**TITLE:** **USE PERMIT NO. 144, PIONEER WOODS 1<sup>ST</sup> ADDITION**, requested by J. Michael Rierden on behalf of Pioneer Woods, L.L.C., for 105,000 sq. ft. of office floor area, with waiver requests to allow signs in the front yard; not to show signs on the site plan; to adjust setbacks where lots abut the outlot; to modify the subdivision requirements so that final plats may be based upon the use permit; and to reduce the front yard setback, on property generally located at the northeast corner of So. 70<sup>th</sup> Street and Pioneers Blvd.

**P.A.S.:** Change of Zone #3368 **DATE:** June 12, 2002  
**Use Permit #144 - Pioneer Woods 1<sup>st</sup> Addition**  
**\*\*As Revised by Planning Commission: 7/10/02\*\***

# **CHANGE OF ZONE NO. 3368 and USE PERMIT NO. 144**

# UP 144 Pedestrian Exhibit

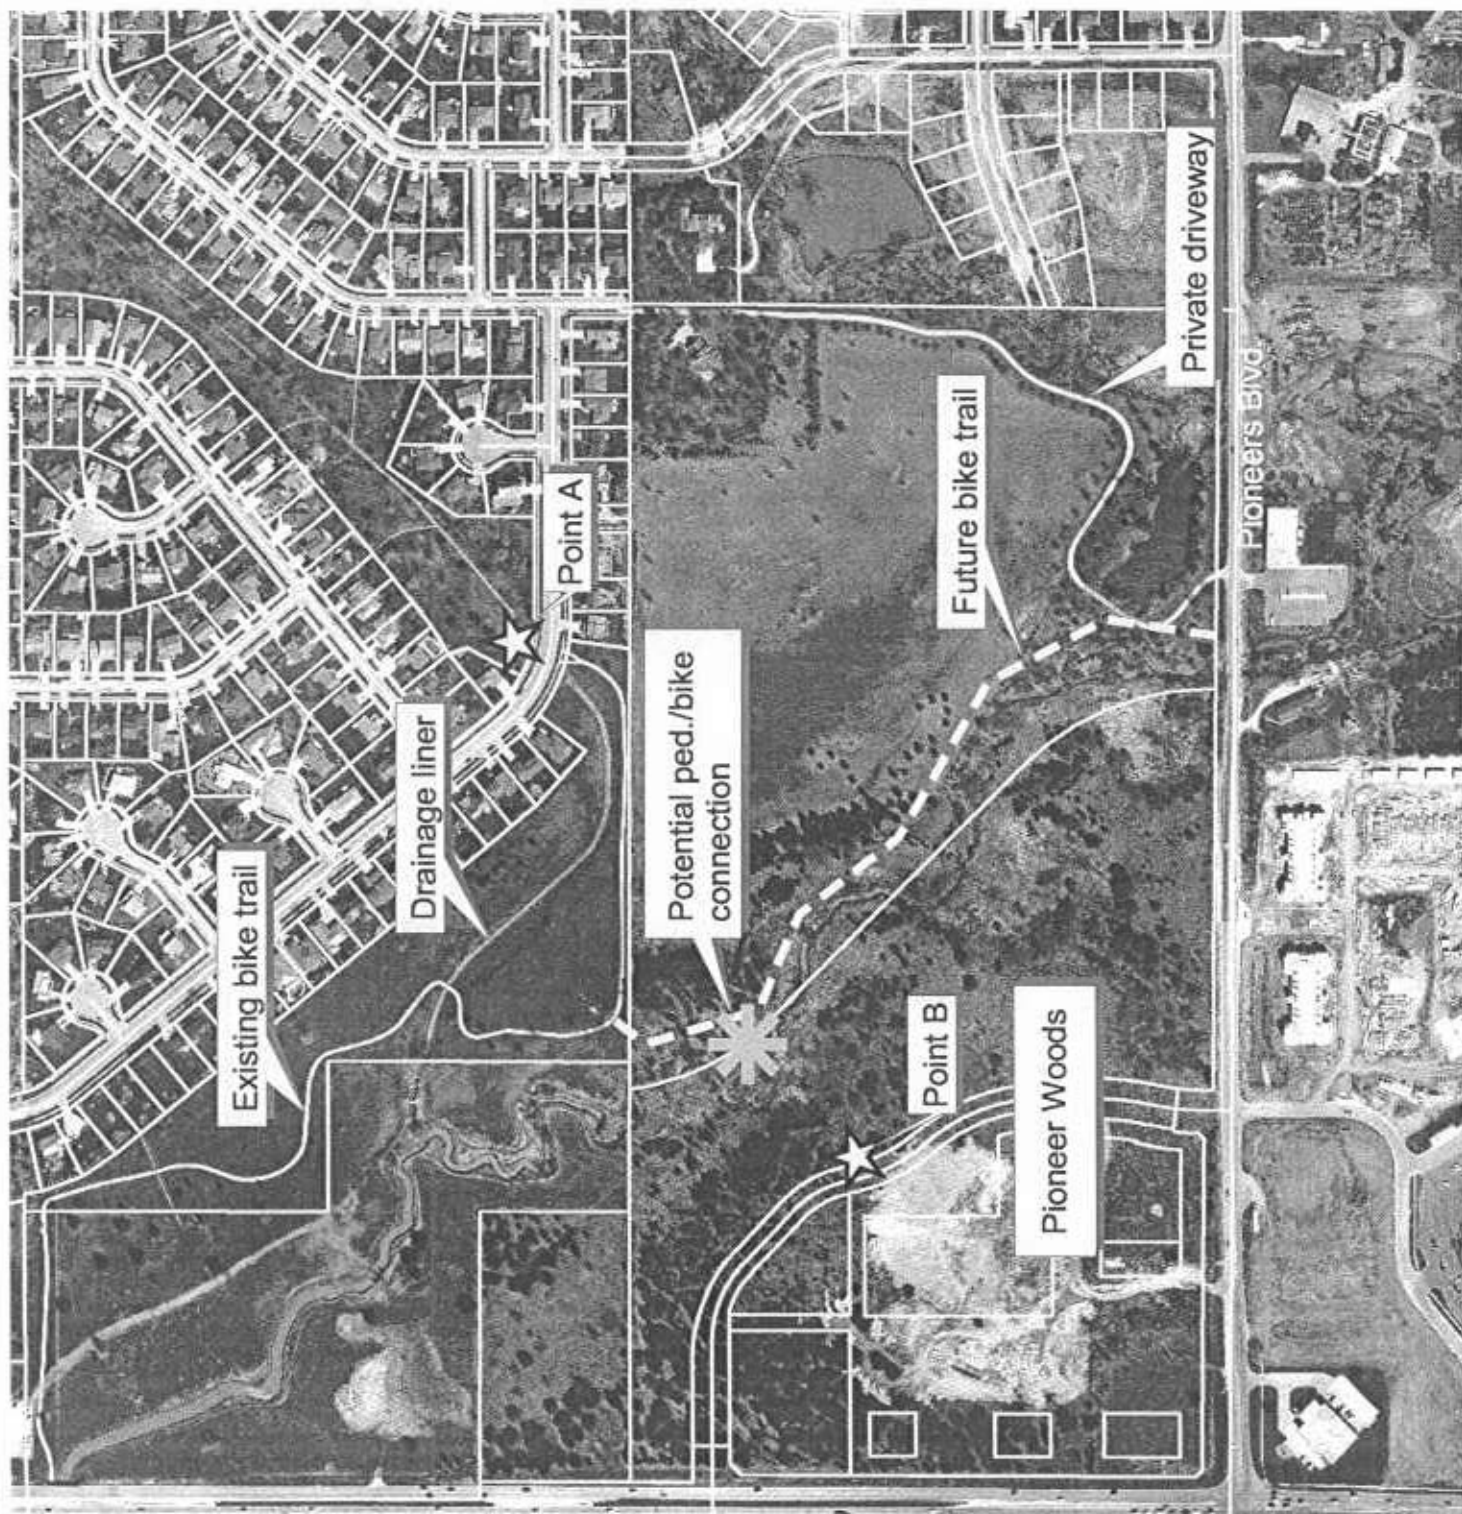
If this development does not provide a pedestrian connection over Antelope Creek, the pedestrian network serving this shopping center is poor.
